# Narrabri Underground Mine Stage 3 Extension Project

Submissions Report

Figure 9 Hoskissons Coal Seam Subcrop Line and Water Supply Bore Locations

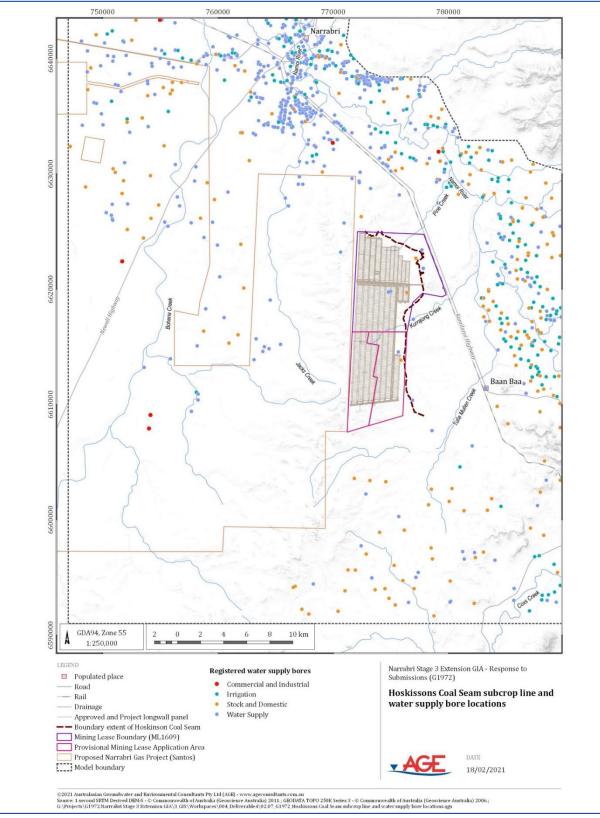
DPIE – Water raised concern that the timing of potential drawdown has not been described in the EIS.

In this case, however, the Hoskissons Coal Seam dips towards the west and, as shown in Figure 9, is largely not present to the east of the Mining Lease Boundary (ML 1609) and MLAs 1 and 2. Accordingly, as shown in Figure 9, none of the water supply bores to the east of these lease areas are considered to be at risk of gas migration, since the Hoskissons Coal Seam is not present in this area. Similarly, gas migration is also considered unlikely to existing water supply bores within the mine lease areas, since none of these bores is deep enough to penetrate into the coal seam.

Additional maps showing the year in which predicted maximum drawdown occurs in each aquifer are provided in Attachment 2. Note that only those areas where the predicted maximum drawdown exceeds 2 m are shown.
